ASSESSMENT REPORT

CUDGEN LAKES SAND QUARRY Modification 1 – Temporary Processing Area (05_0103 MOD 1)

Figure 4: Distance to approved subdivision and Residence A

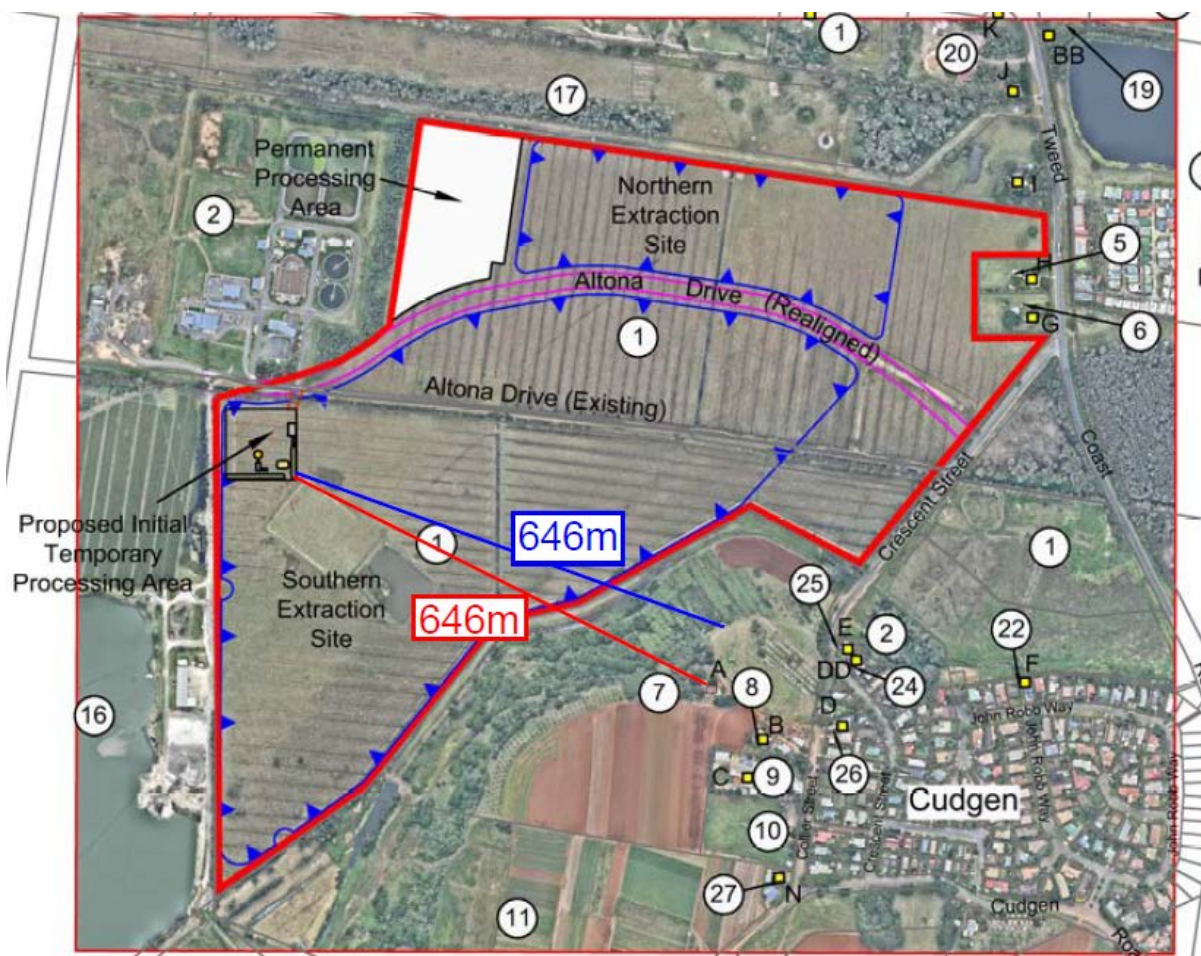
Council requested that additional assessment be undertaken for air quality impacts on a recently-approved 40-lot subdivision to the southwest of the proposed temporary processing area. Gales-Kingscliff's RTS clarified that Residence A (which is considered in the AQIA 2015), is at the same distance as the closest subdivided block within the approved subdivision immediately northeast of Residence A (**Figure 4**). Therefore, Gales-Kingscliff deemed this site representative of the 40-lot subdivision. The Department accepts this position.

The temporary processing area would be located approximately 200 m southwest of the approved permanent processing area, closer to residents to the south and southeast. The NIA 2015 labelled the closest receivers to the temporary processing area as B, DD and O (**Figure 4**). In response to Council's submission, the Department requested that noise modelling was undertaken for the recently-approved 40-lot subdivisions.

Figure 5: Alternative office locations

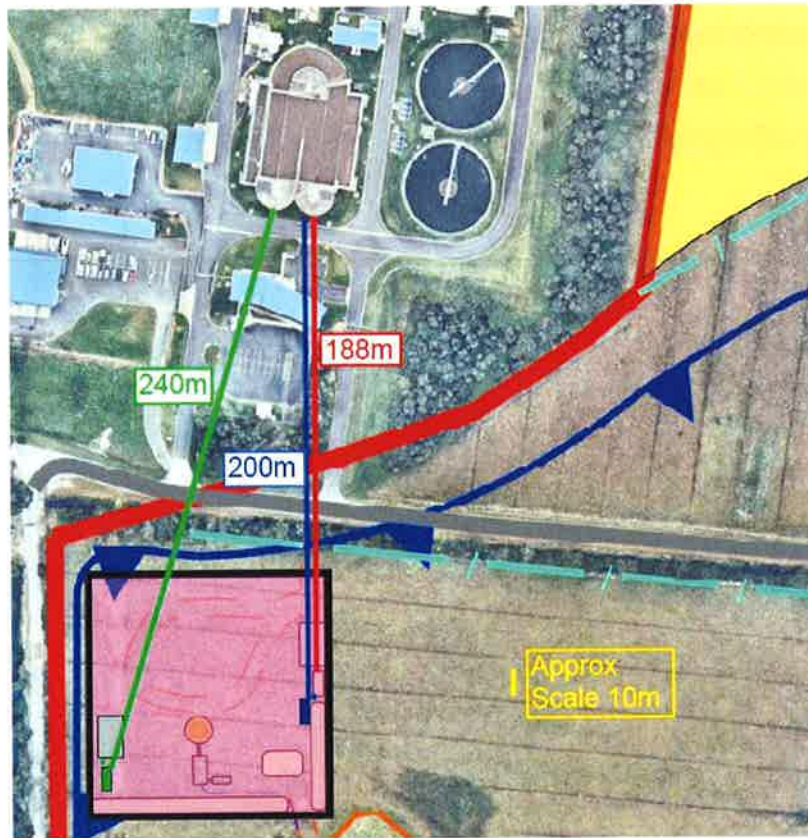
The proposed temporary processing area is located adjacent to Council's WWTP. Council raised concern over the location of the temporary office facilities within the proposed processing area, as its DCP sets a 200 m 'no development' buffer (with the exception of open air facilities) around the WWTP.

In response, Gales-Kingscliff proposed two alternative locations for the temporary office facilities, located at 200 m or 240 m from the WWTP (**Figure 5**). The Department has recommended that the furthest location of 240 m be adopted and that the office facilities are designed and constructed according to the requirements of the DCP including:

- ventilation emanating from the side facing away from the WWTP; and
- office facilities to be air conditioned.
